**SUBJECT: PALO VERDE NUCLEAR GENERATING STATION, UNITS 1, 2, AND 3 –
STAFF ASSESSMENT OF RESPONSE TO 10 CFR 50.54(f) INFORMATION
REQUEST – FLOOD-CAUSING MECHANISM REEVALUATION (CAC NOS.
MF5546, MF5547 AND MF5548)**

STAFF ASSESSMENT BY THE OFFICE OF NUCLEAR REACTOR REGULATION

RELATED TO FLOODING HAZARD REEVALUATION REPORT

PALO VERDE NUCLEAR GENERATING STATION, UNITS 1, 2, AND 3

Figure 3.2-1. LIP Hyetograph for the PVNGS Site (APS, 2014, FHRR Figure 3-2)

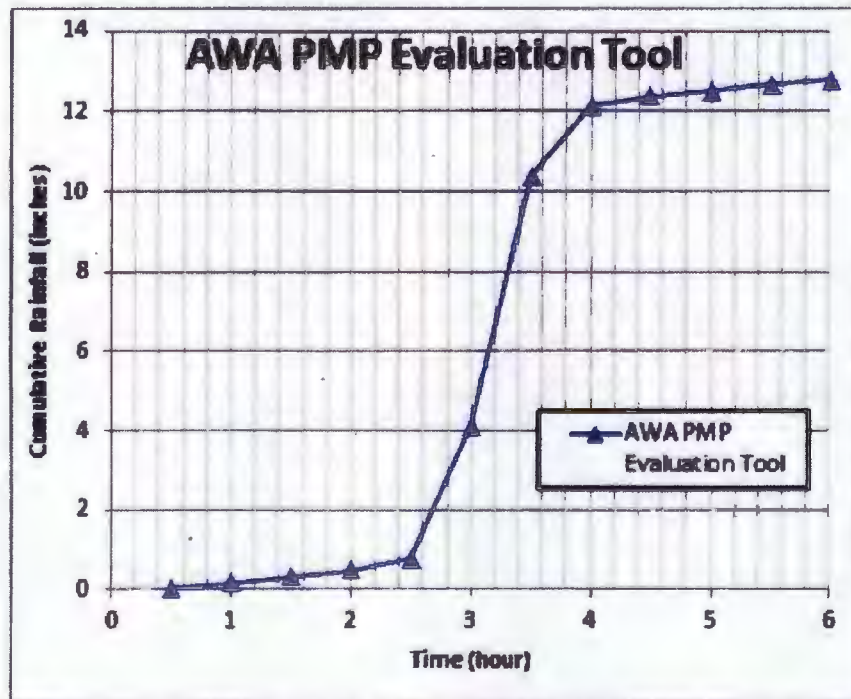
Arizona (AWA, 2013). As reported in the FHRR (APS, 2014), the AWA study relied on a 6-h, 1-mi² (3-km²) LIP event; according to that study, based on both updated meteorological record as well as numerical processing techniques, the site-specific PMP event was found to produce a lower cumulative rainfall depth of 12.8 in. (32.5 cm) over 6 hours. In deriving the LIP event used in the FHRR, the licensee assumed that peak rainfall intensity occurred at the midpoint of the thunderstorm event, as shown in Figure 3.2-1, with a maximum 10-min incremental rainfall depth of about 2.7 in. (6.9 cm), and a maximum 1-h rainfall depth of 10.7 in. (27.2 cm) (APS, 2014).

Figure 3.2-3. FLO-2D Model Domain (in blue) for the LIP Flooding Evaluation. VBS shown in red, buildings in orange.

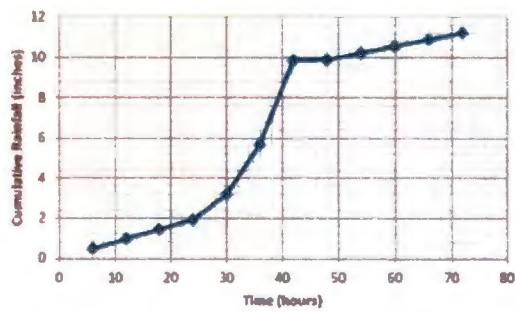
The licensee defined outflow cells along all boundaries of the FLO-2D modelling domain to allow surface water reaching any boundary location to flow out of the modelling domain. Most of the southern boundary of the computer model was located along the containment berm constituting the northern edge of the on-site evaporation ponds. The higher elevation of the berm, reported to extend 14 ft (4.3 m) above grade, limited the amount of outflow from those particular grid cell locations. Based on the topographic information provided by the licensee, the staff found the licensee's use of the outflow boundary conditions for the FLO-2D model appropriate. The FLO-2D model, which was reviewed by the NRC, had boundary and other key model features as shown in Figure 3.2-3.

Figure 3.3-2. PMP Hyetographs for Winters Wash and East Wash Watersheds (APS, 2014, FHRR Figure 3-6)

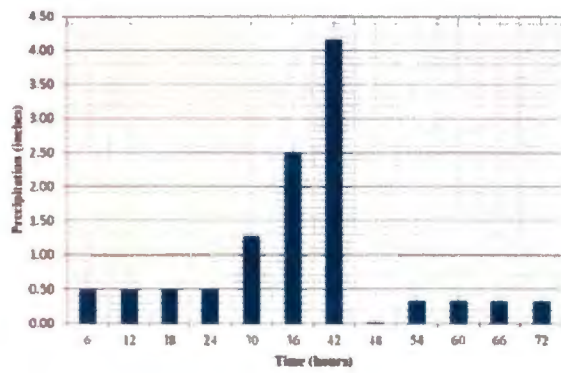
For the purposes of the FHRR, two separate PMP events were considered corresponding to the two respective drainage basins based on a study completed for the State of Arizona (AWA, 2013). For the Winters Wash drainage basin, the licensee used a 72-h duration tropical storm with a cumulative rainfall depth of 11.2 in. (28.5 cm) (APS, 2014). Peak rainfall intensity occurred 42 hours after the start of the event, with a maximum intensity of 4.2 in. (10.6 cm) over a 6-h period, as shown in Figure 3.3-2. For the smaller area of the East Wash drainage basin, the licensee used a 6-h duration local storm with a cumulative rainfall depth of 10.1 in. (25.6 cm) with a peak intensity of 2.1 in. (5.3 cm) over 10 min occurring 3-h after the start of the event, as also shown in Figure 3.3-2.
